3831 MAIN STREET DE 407525

CITY OF VANCOUVER PLANNING DEPARTMENT

| COMMERCIAL - RESIDENTIAL BUILDING                       | <b>ESZTER CSUTKAI ARCHITECT</b>   | A3                                     |

**Urban Design Panel Minutes**

FRONT ELEVATION, MAIN STREET

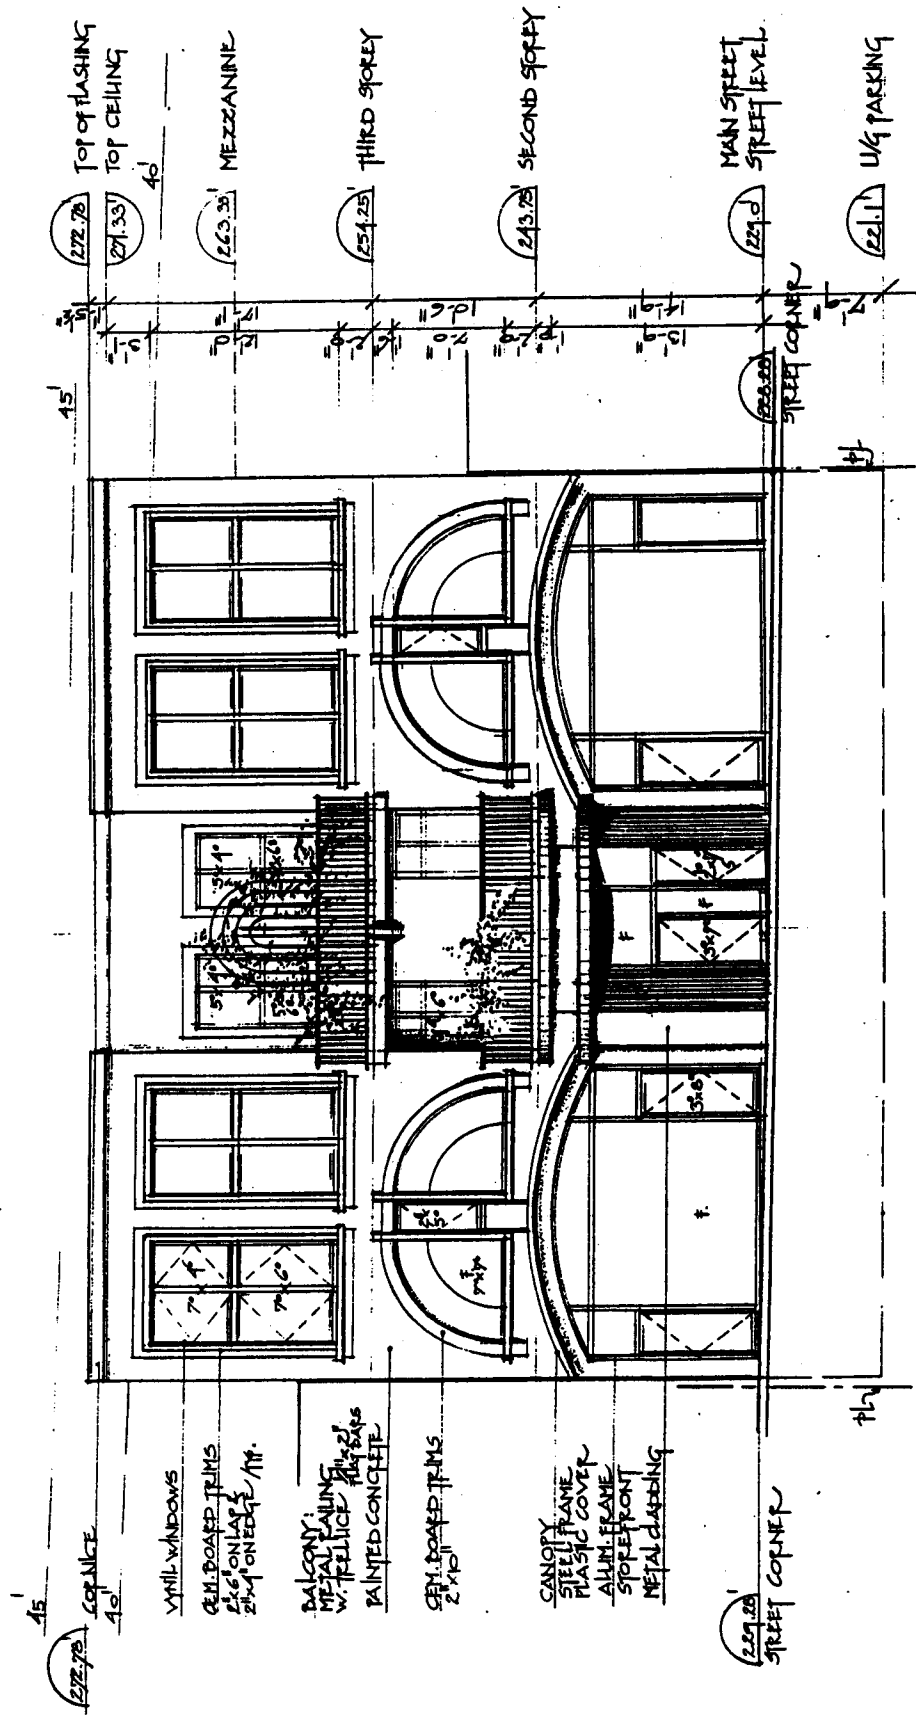
The proposed plastic canopy was not supported and the use of a glass canopy, perhaps sandblasted for opaqueness, strongly recommended instead. A sturdier canopy material will be easier to maintain as well as achieve the desired curvature.

The Panel's main area of concern related to the second level of the Main Street elevation which was thought to require significant design development. There was considerable discomfort with the shape and proportions of the curved windows. They don't seem to belong to the rest of the building and detract from the quality of the main floor retail windows. A comment was made that curved windows are more typically seen at tops of buildings (eyebrows) than in the middle. Given the large amount of glazing on the front façade, with very little solid wall, resolution of the details of the interface between the glazing and the concrete panel system will be extremely important to this project.

The streetscape at the base was thought to be well handled and there were no serious concerns about the top floor. There was one suggestion that the Main Street cornice line appears to end too abruptly.

**Applicant's Opening Comments:** Eszter Csutkai, Architect, addressed areas of change noting that the serious concern about 2<sup>nd</sup> floor rounded windows was expressed previously. The design has now been modified to provide squared windows.

The architect noted that she has checked many areas around the city and noted that the proposed canopies (canvass) are the similar to those used in numerous other locations in Vancouver. The suggested use of glass canopies is not feasible.

The sign location has been extended to 3 possible locations: one on the face of the canopy; one inside and above the window and a further option of a banner hanging perpendicular to the canopy. The cornice has been cut back with a gentle sloped angle. Weather protection is proposed for the top balcony and the front of the building.

SOUTH SIDE ELEVATION

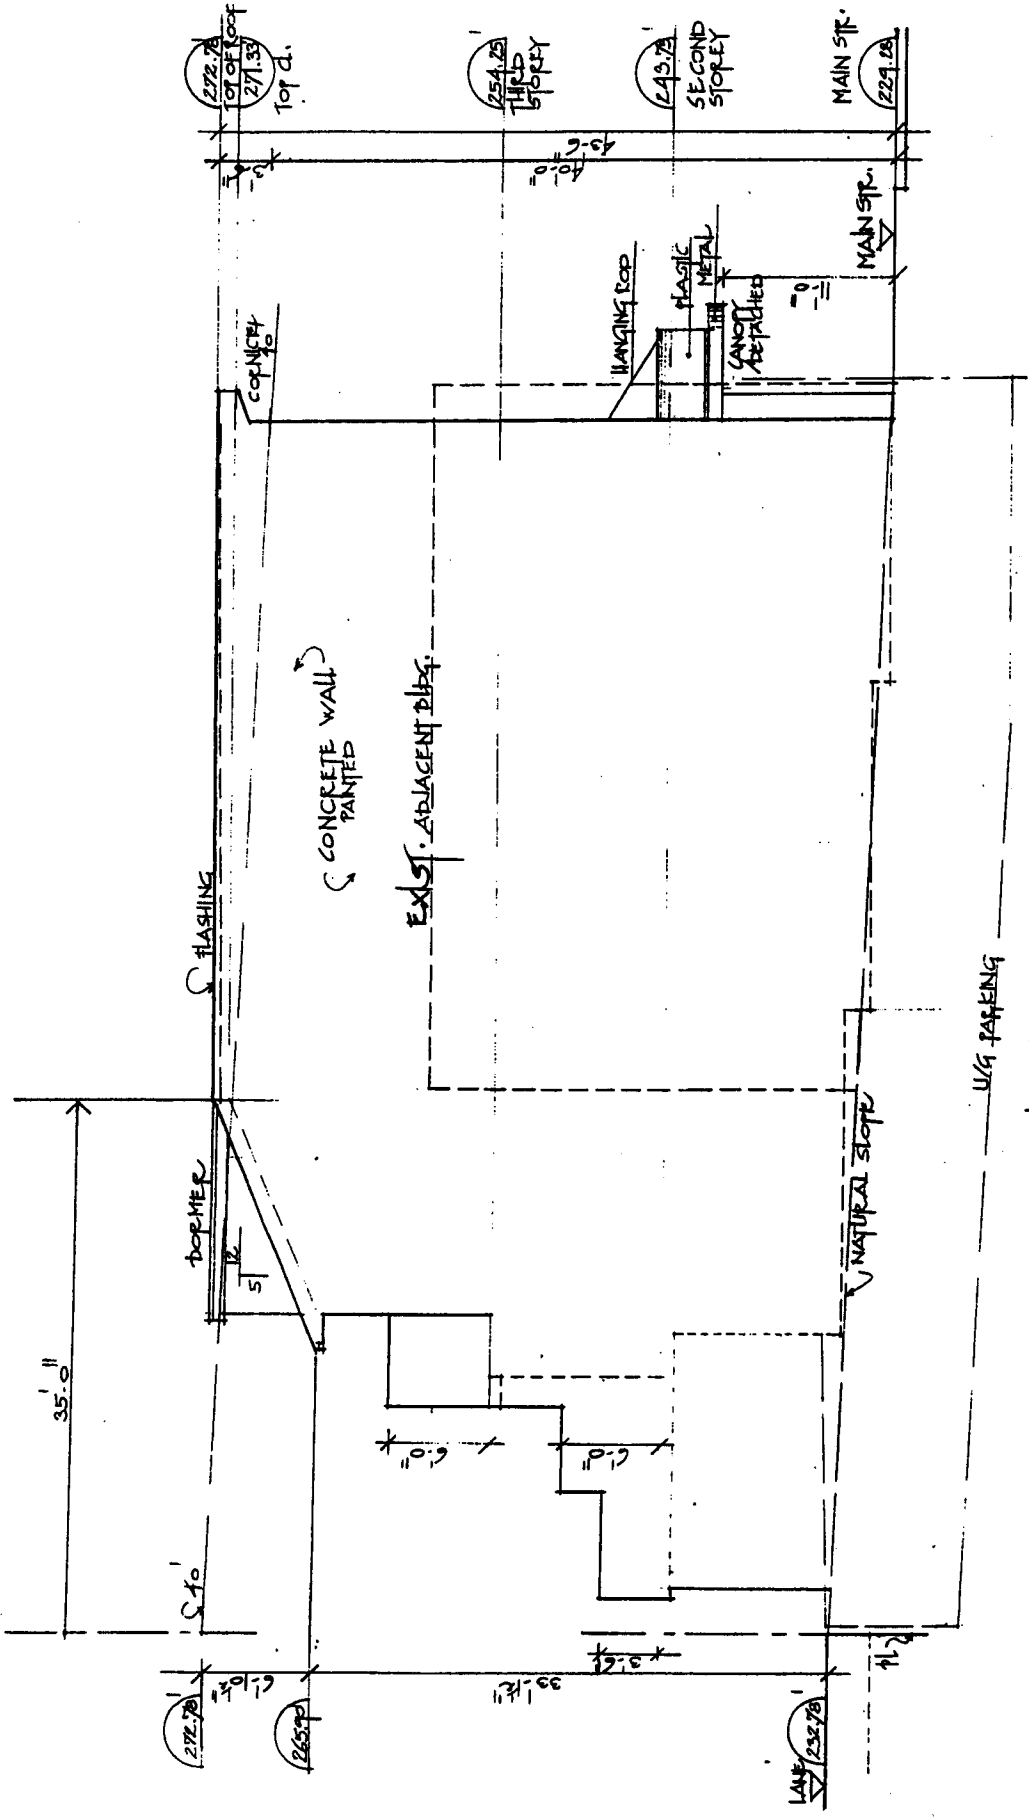
Some Panel members commented that the character of the front and rear of this building are totally different, suggesting there should be more integrity in the façade design.
